ARDEN CONSULTING ENGINEERS, PLLC

Re: Application for Subdivision & Site Plan Approval
1251 Kings Highway, LLC
Premises: 1251 Kings Highway (SBL 17-1-99.21)

Response to Comments

Warehousing (150)

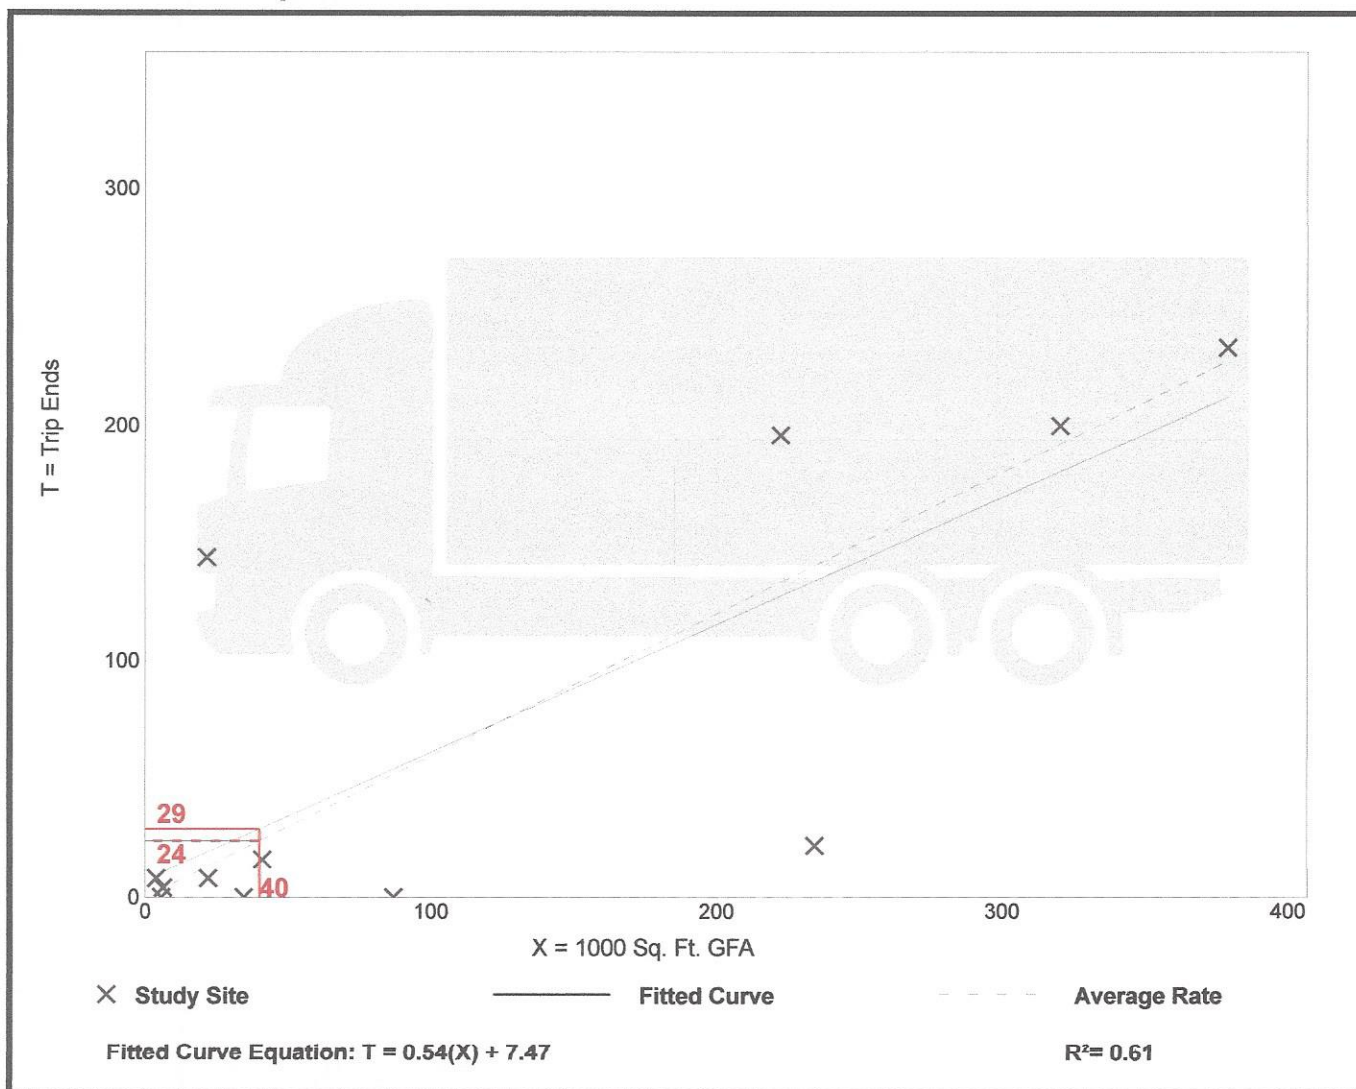
ITE Trip Generation, 10th Edition + supplement, was utilized to determine the average daily truck trips generated for each warehouse. It appears that 24 average daily truck trips will be generated for each warehouse. This appears to be a very conservative number for a 40,000 SF warehouse. The Full EAF has been updated to reflect this truck traffic information. A copy of the ITE trip generation data plot has been attached to this letter for reference.
